**From:** Rich Lucia  
**Sent:** Wednesday, August 6, 2025 9:22 AM  
**To:** Cstaff  
**Subject:** FW: Barrington Bridge Repairs 2025-02-078  
**Attachments:** CRMC Public Comment\_Response Letter\_SIGNED\_8.6.25.pdf

**Subject:** Barrington Bridge Repairs 2025-02-078

RE: Response to Public Comments  
CRMC Assent No. 2025-02-078  
Rehabilitation of Bridge Group 15F –  
Barrington Bridge No. 12301

Figure 1: Elevation view of the Barrington Bridge, including existing and proposed conditions.

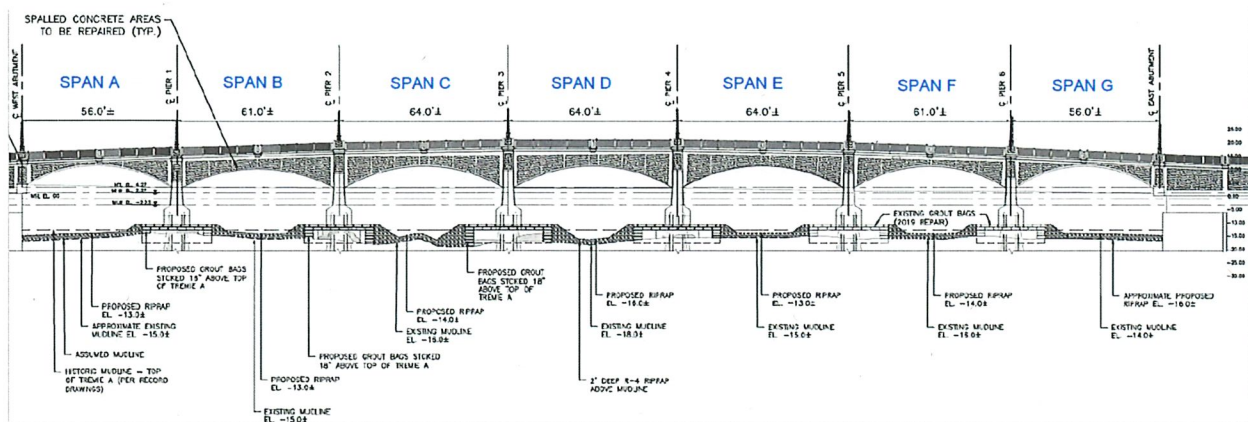
Amy, I'm on the Warren Harbor Management Commission, and at our meeting last night we discussed this permit application for repair work on the Barrington River Bridge. We had a question about the flow projections in Appendix C. It appears to us that the work described will make the openings under the bridge arches both narrower and shallower than present due to the addition off grout bags around the bridge pillar structures and the addition of 2 feet of rip rap on the river bottom under the arches and sloping upwards around the bridge pillars on the outside of the grout bags. It seems to us that a narrower and more shallow channel would necessarily increase the flow at peak tides as the volume of water seeks to find its level through a smaller space. The modeling described in Appendix C concludes there will be no change in flow while tide heights remain the same at MHT and MLT. The flow through this bridge now is significantly increased over the course of the tide cycle with water levels backing up against the pillars at peak tides. The increased flow is markedly greater during king tide cycles.

At peak tides the current through this bridge is already difficult for small boat traffic, kayaks, etc. We are concerned that this repair work will make the bridge even more dangerous during peak tides. Even if flow does not increase, which seems unlikely to us, the raising of the river bed with rip rap will make for a much more shallow passage at low tide especially in the arches near either end of the bridge. Does your technical staff agree with the conclusions in Appendix C that flow and tide heights will not increase?

The comment from the Warren Harbor Management Commission sited two concerns; increased flow velocities under the bridge during storm surge events and shallow water depths under the outer-most arches. The Hydraulic Report prepared by Pare Corporation and included in the CRMC Assent Application as Appendix C is referenced in the comment, questioning the conclusion that “the installation of scour counter measures is not expected to result in any notable impacts to

the hydraulic conditions within the vicinity of the bridge or elsewhere within the river.” The basis of this conclusion is from a hydraulic model of a hypothetical condition at the bridge with a constant streambed elevation of El. -12.0 from abutment to abutment. The results of the hydraulic model revealed that no notable changes to the hydraulic conditions occur within the vicinity of the bridge during normal tide, the highest astronomical tide, a 10-year storm surge, and a 100-year storm surge. It is important to note that the hypothetical condition is shallower than the proposed condition, which varies in depth from El. -13.0± to El. -16.0±, meaning that the hypothetical condition was a conservative model.

As you can see from Table 1 above, the proposed water depths will range from just below eleven feet to just above eighteen feet during normal low and high tide conditions, respectively, which is one-foot deeper than the depth to the historic mudline. The water depths at the outer-most arches can be found in the columns for Span A and Span G.
